DEP15434

Req # DEP 15434 Morris Creek (Jackson) Drainage Addendum #1

ADDENDUM NO. 1

CONVEYANCE PIPE DETAIL BENEATH ROUTE 61/9

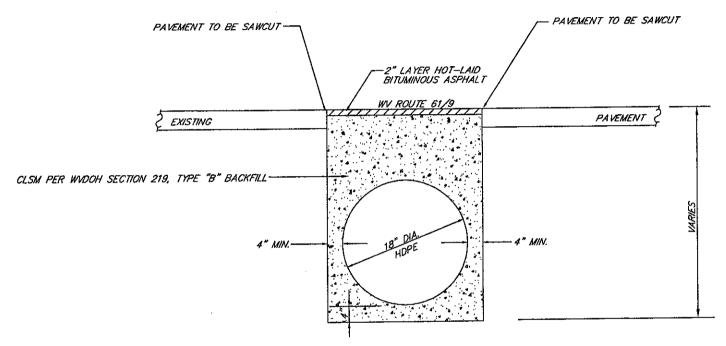
Sheet 4 of 8 – "DRAINAGE PROFILES AND DETAILS" – REPLACE "CONVEYANCE PIPE DETAIL BENEATH PAVED ROAD" with revised and attached new drawing of "CONVEYANCE PIPE DETAIL BENEATH ROUTE 61/9". The new drawing shows backfilling with a flowable fill as per WVDOH request.

Add Specification 7.2.8 – Highway Pipe Backfill – Backfill of the 18" diameter hdpe pipe under Route 61/9 shall consist of Controlled Low Strength Material, Type B as per Section 219 of the WVDOT Standard Specifications for Roads and Bridges.

NOTE: ANCHOR PIPE SO TO PREVENT FLOATING DURING BACKFILLING OPERATIONS.
